Access Compliance Report

Public Rights-of-Way

(Curb Ramps)

Intersection ID: 28317	Main Street: ANDREA_WY	Cross Street: ZACKERY_AV	Location: NE
ADA ID: 9B8DA03F8E7C	Ramp Type: BlendTrans2	Initial Pass/Fail: Fail	Overall Compliance: No
			Severity Score: 21.25

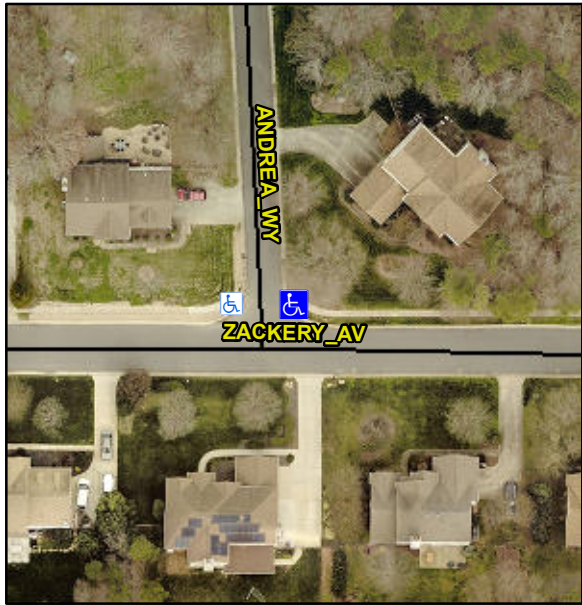
Codes/Mitigation Info/Possible Solution			Field Measurements/Component Compliance					
	Possible Solutions:		Compliance	Description	Data	Compliance	Description	Data
	Remove & Replace Curb Ramp With Two New Directional Ramps or Equivalent.		N/A	Ramp Length (in)	96.0	Yes	BlendTrans Slope (%)	4.9
			No	Ramp Width (in)	47.0	No	BlendTrans XSlope (%)	5.3
			N/A	Flare Type LT	N/A	N/A	Flare Type RT	N/A
			N/A	Flare Slope LT (%)	N/A	N/A	Flare Slope RT (%)	N/A
			N/A	Flare Traversable LT?	N/A	N/A	Flare Traversable RT?	N/A
			N/A	Landing Length (in)	N/A	N/A	DWS Provided?	N/A
			N/A	Landing Width (in)	N/A	N/A	DWS Contrast?	N/A
			N/A	Landing Slope (%)	N/A	N/A	DWS Length (in)	N/A
			N/A	Landing X Slope (%)	N/A	N/A	DWS Full Width?	N/A
<p>Surveyor Notes:</p> <p>N/A</p> <p>PROW/ADA:</p> <p>Not Found, R304.5.1, R304.5.3</p>			N/A	Landing Curb? (Y/N)	N/A	N/A	DWS Offset (in)	N/A
			N/A	Shared Landing?	N/A			
			N/A	Gutter Ponding?	N/A	N/A	Gutter Slope (%)	N/A

N/A	Gutter Lip Ht (in)	N/A	N/A	Gutter X Slope (%)	N/A
			N/A	Painted X Walk1?	No	N/A	Painted X Walk2?	No
				X Walk 1 Direction	To W		X Walk 2 Direction	To S
				X Walk 1 Width (in)	N/A		X Walk 2 Width (in)	N/A
				X Walk 1 Slope (%)	2.2		X Walk 2 Slope (%)	1.4
				X Walk 1 X Slope (%)	0.3		X Walk 2 X Slope (%)	3.0
			N/A	Ramp inside XWalk1?	N/A	N/A	Ramp inside XWalk2?	N/A
				Road Slope (%)	1.1		Clear Space?	N/A
				Road X Slope (%)	2.8	N/A	Clear Space to XWalk (in)	N/A
			N/A	Any Obstructions?	N/A	N/A	Storm Grate/Utility Hazard?	N/A
				Obstruction Type			Storm Grate/Utility Type	
					N/A			N/A
						Yes	Surface Condition? (G/P)	Good
						No	Curb Slope (%)	12.9
